Aspire 2 - Design Change Legend

Aspire Tucson 2

Concept Design View - N Park Ave Mid-air - Changes

Concept Design View - E 1st St & N Park Ave - Changes

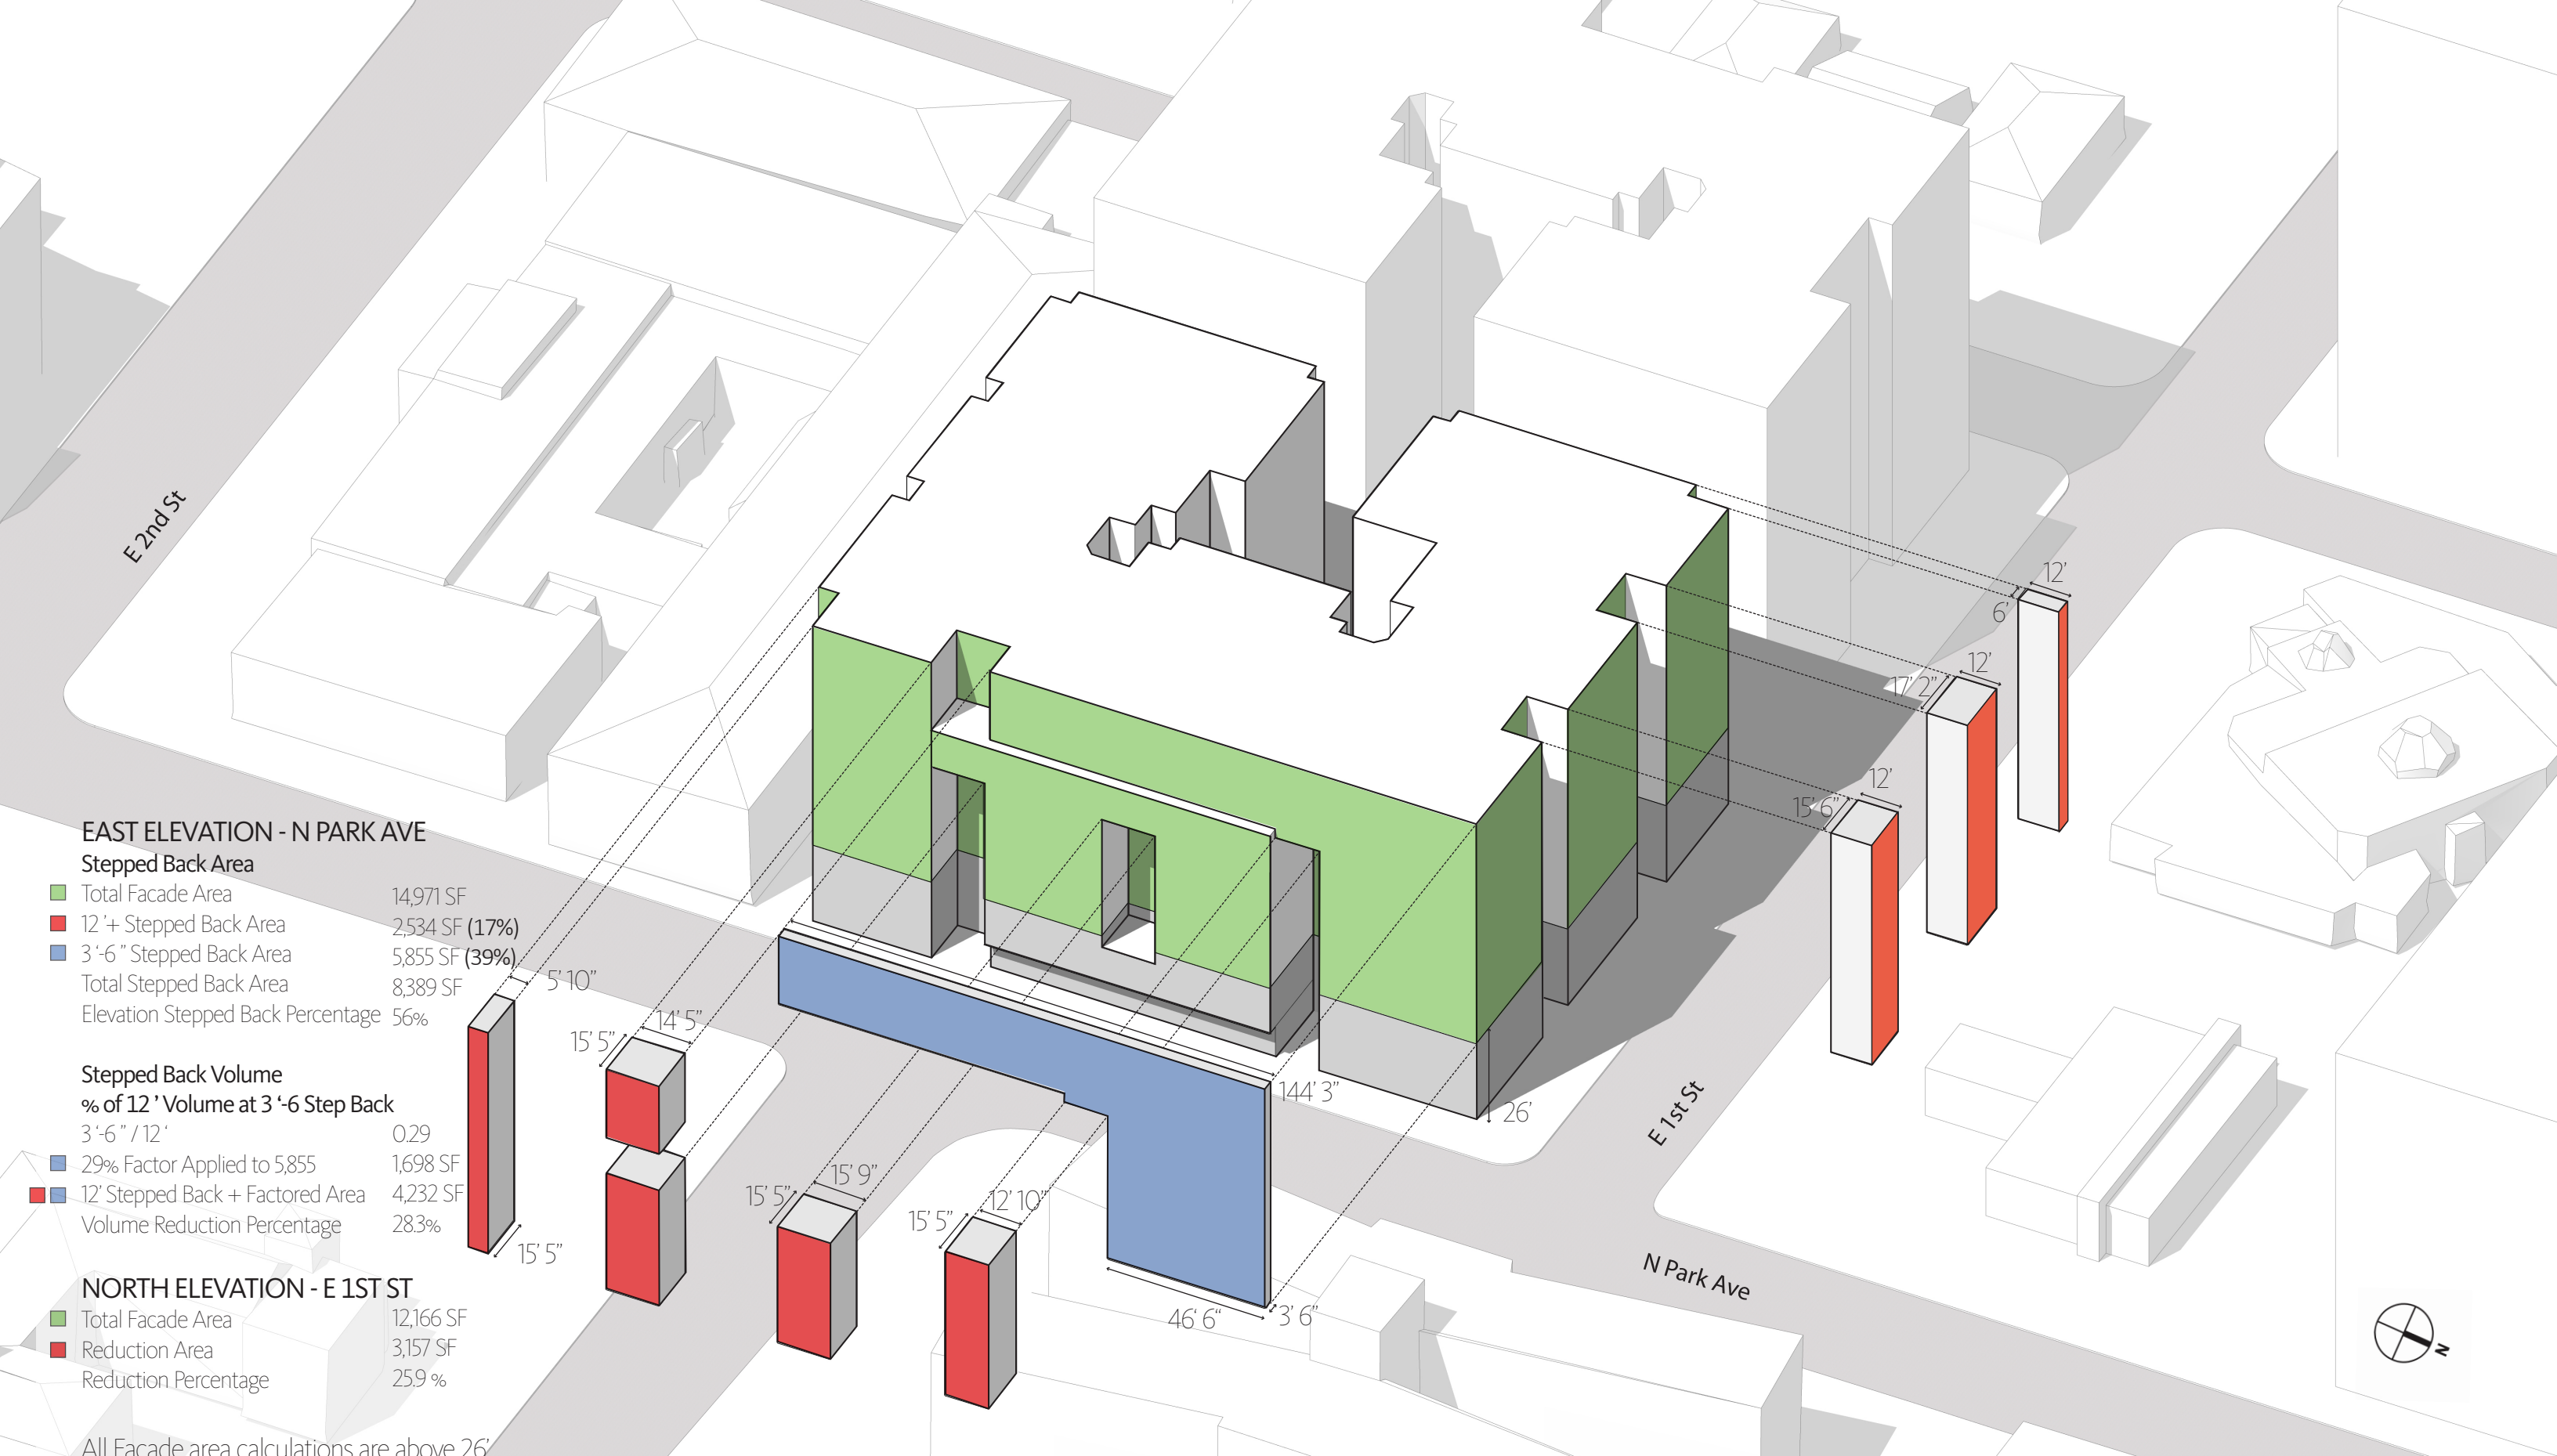
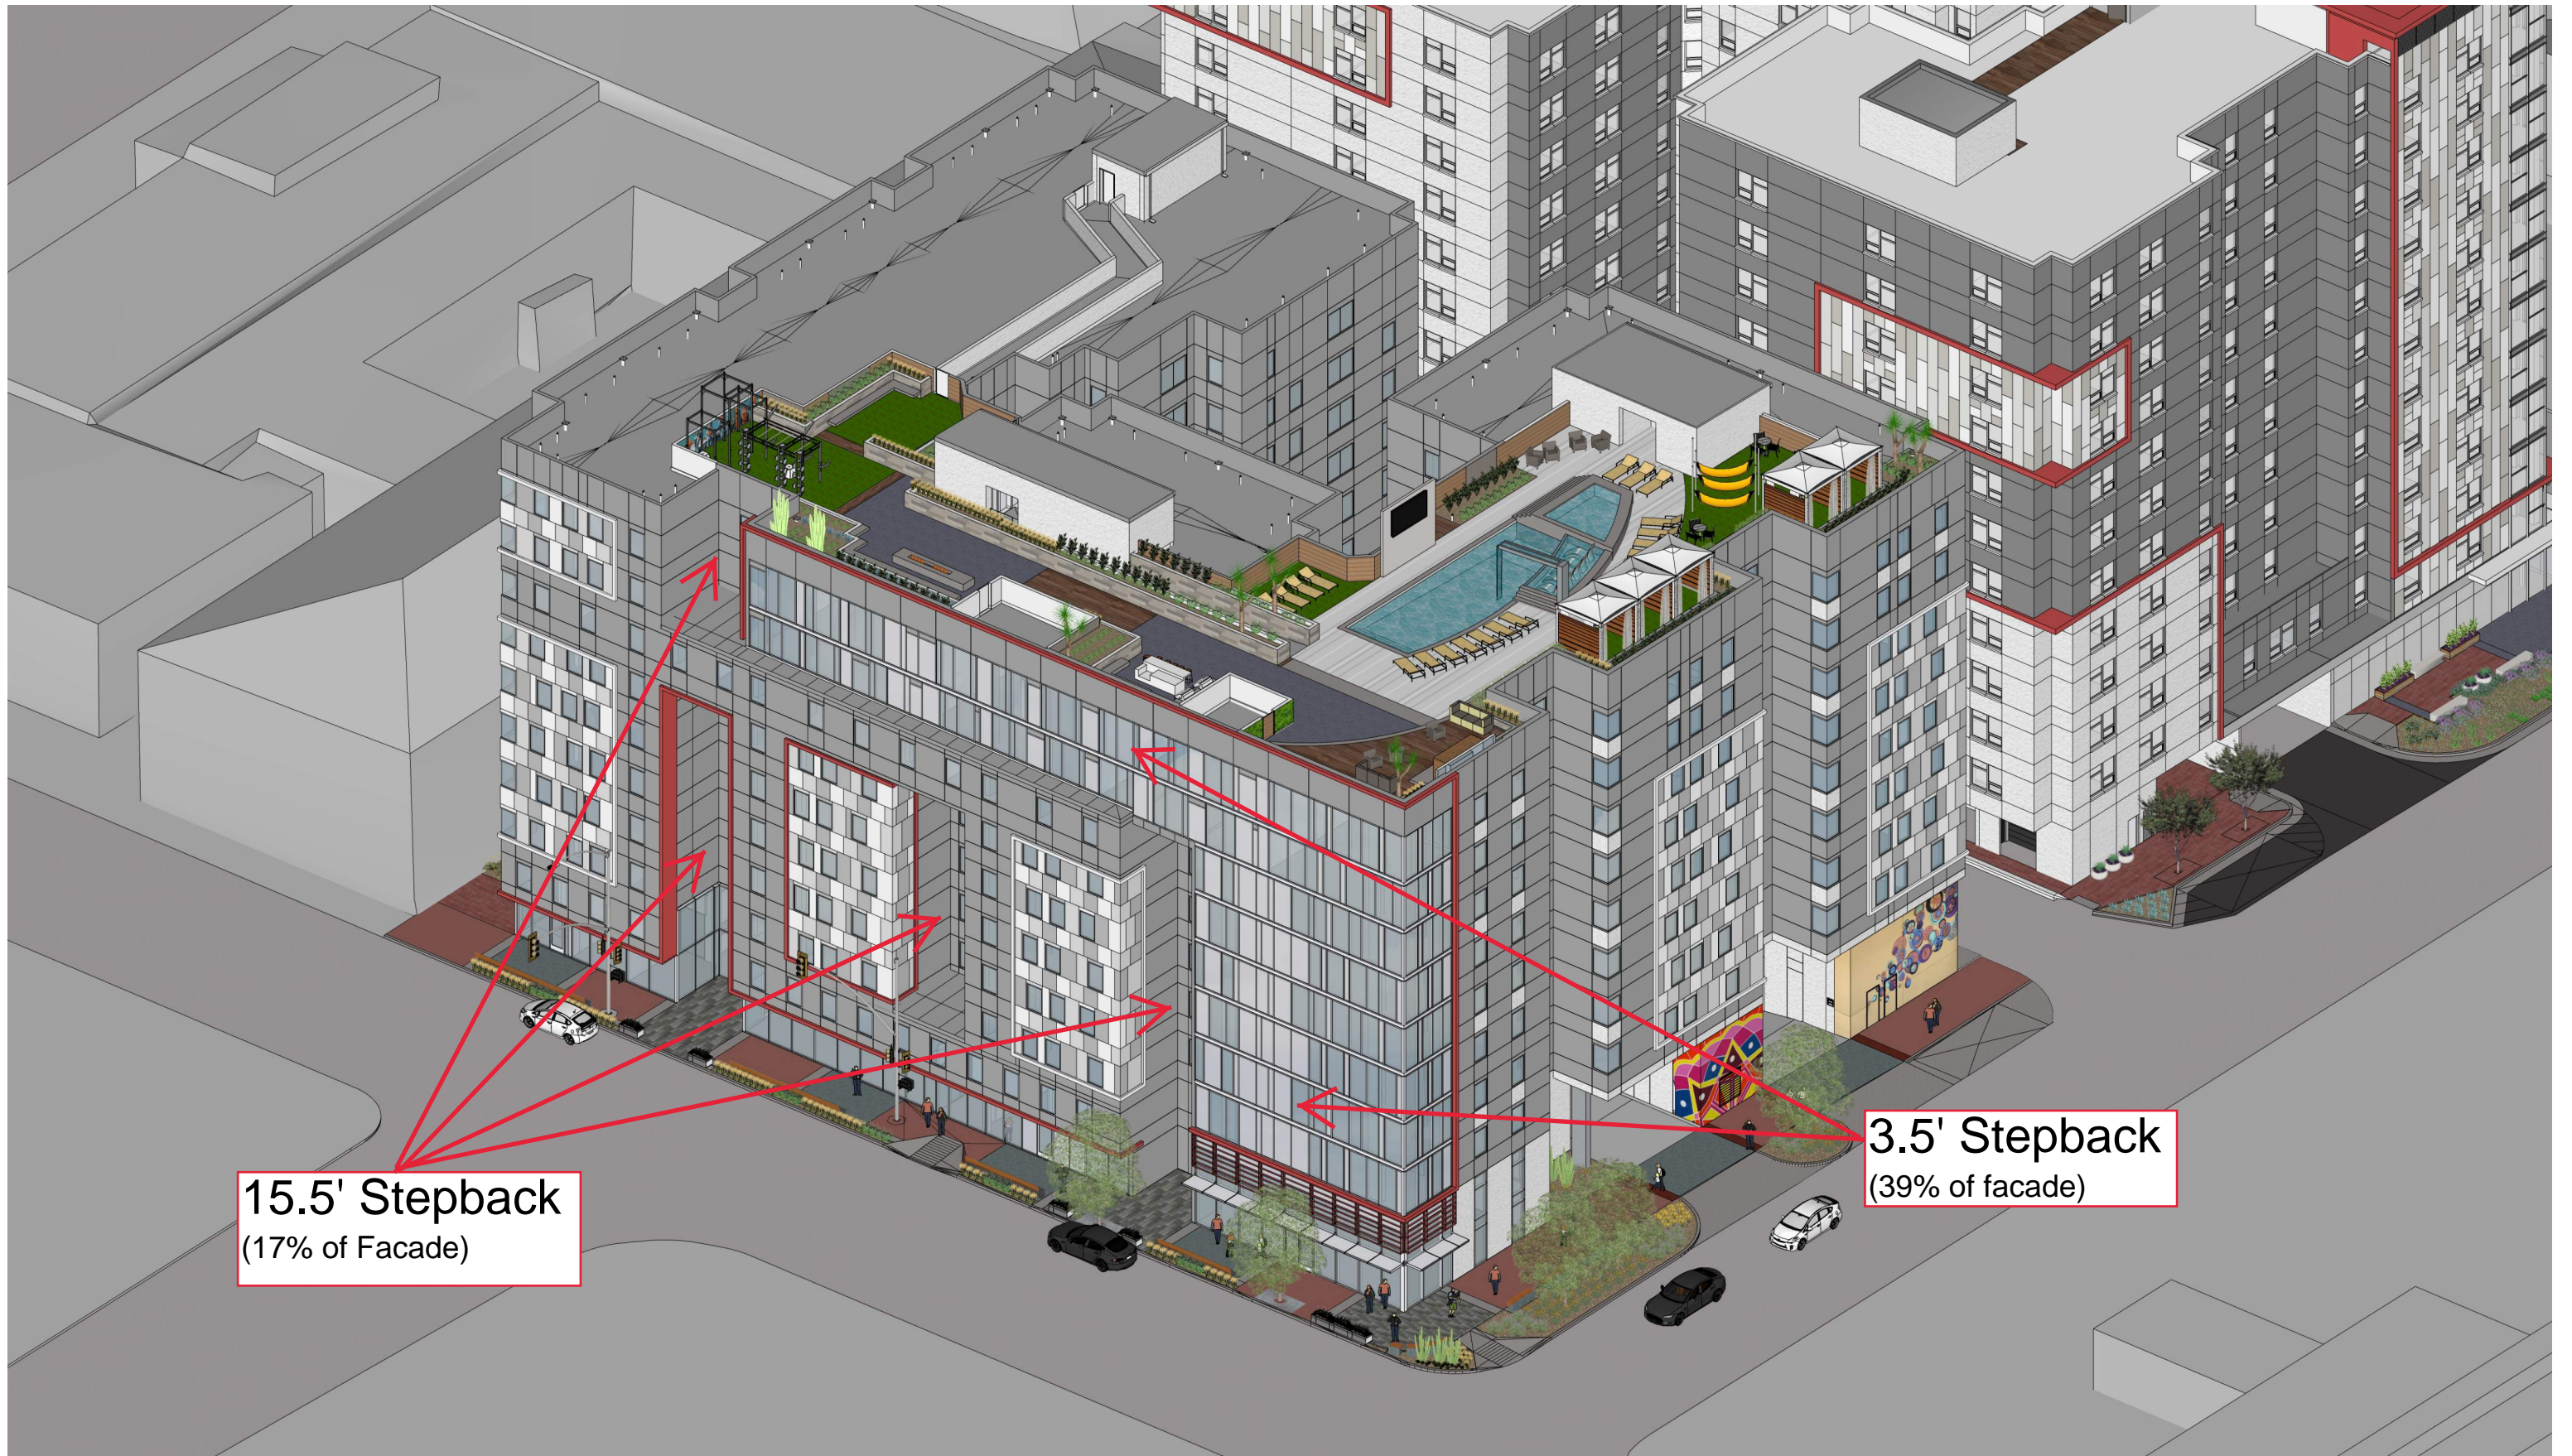
- A - WINDOW TYPE CHANGED
- B - WINDOW LOCATION ADJUSTED
- C - WINDOW REMOVED
- D - WINDOW ADDED
- E - RED BAND LOCATION ADJUSTED
- F - ADDED MECH LOUVERS

- G - ROOF CORE/MECH SPACE UPDATED
- H - UPDATED SCREEN/GATE DESIGN
- I - DOOR TYPE CHANGED
- J - RENDERING ADJUSTED TO SHOW CORRECT FRAME SIZE
- K - MODIFIED AREA OF METAL CLADDING
- L - WALL MOVED

- M - COURTYARD PARAPET ADJUSTED
